AMENDMENTS TO THE DRAWINGS:

ASSEMBLY JIG AND MANUFACTURING METHOD OF MULTILAYER SEMICONDUCTOR DEVICE Inventor: Yoshiyuki Yanagisawa et al.

Serial No. 09/876,290

FIG.5(a)

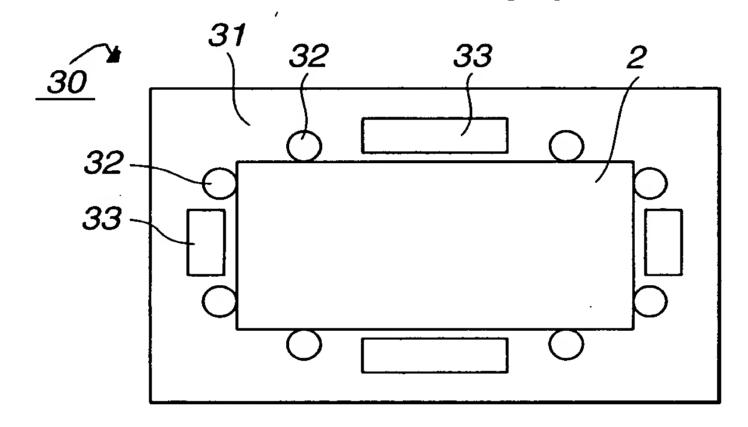
The attached sheet of drawings also include changes to Fig. 2(f), 5(a), and 5(b).

The sheet which includes Figs. 5(a) and 5(b) replaces the original sheet including Figs. 5(a0,

5(b), and 6. The lead lines requested by the Examiner have been added.

classified as a "semiconductor module." The plan view in Figure 5(b) shows an upper or

lower most semiconductor module 2. Because this is a top view, the reference numeral 2

corresponds to the top semiconductor module 2d when the cover 34 is removed.

restriction mechanism (for example, 32 in Fig. 5a), a height restriction mechanism (for

example, 34 in Fig. 5a), and a mother substrate alignment mechanism (for example, 22 in Fig.

FIG.5(b)

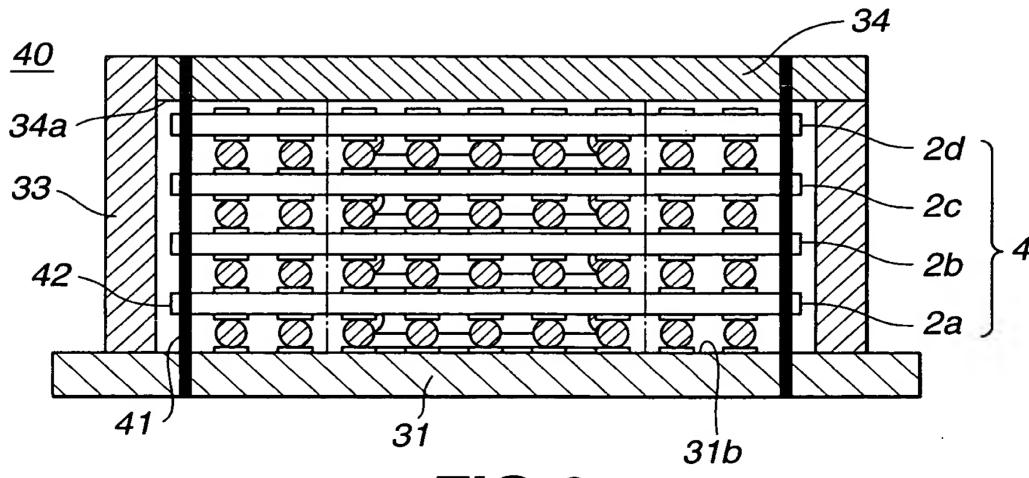
In regard to claim 12, support for this claim can be found starting at the top of page 20 of Applicant's disclosure, and in Fig. 5(b), which shows positioning pins 32 arranged adjacent to and in contact with sides of the stacked semiconductor modules 2.
